MODIFICATION FOR OPERATION BEAR! ATT. MR. TREDERSE

OPERATION BEAR

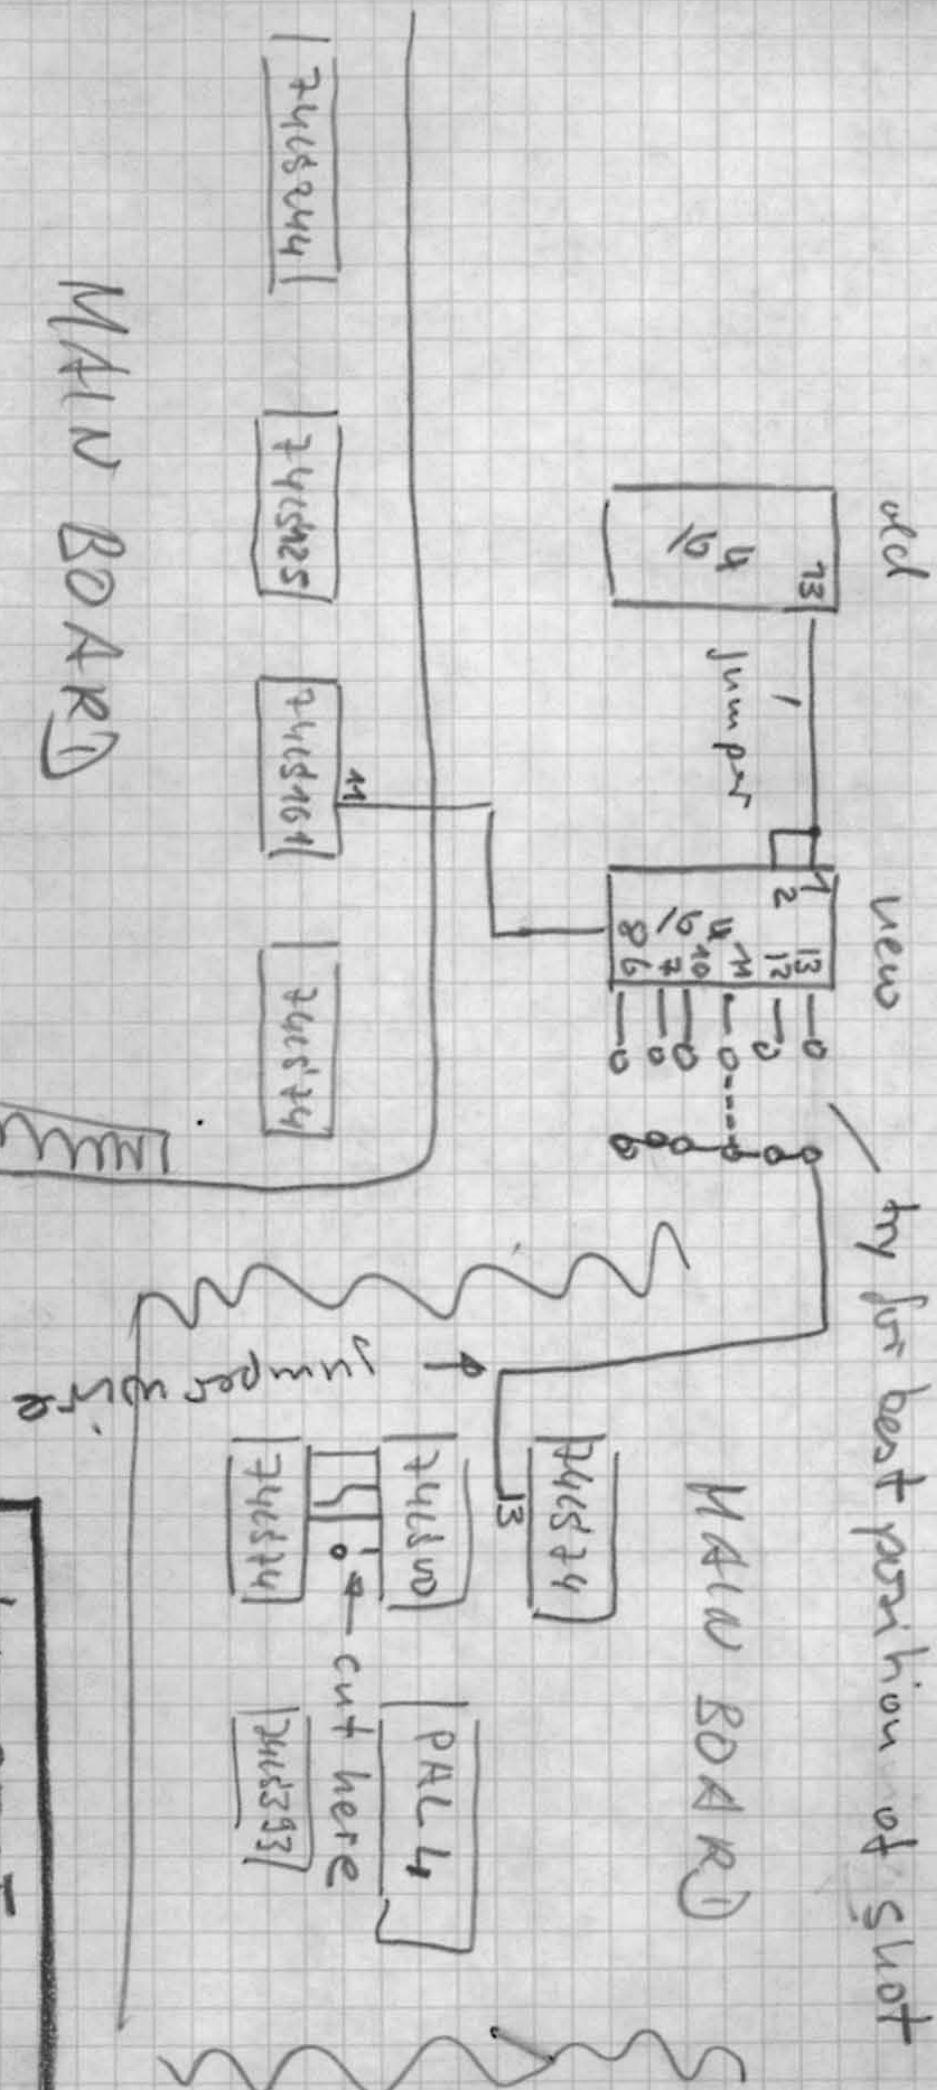
- There is a 74LS164 mounted near the EP 1200
- Add another 74LS164 upon that chip and connect only pin 8, 10, 14.
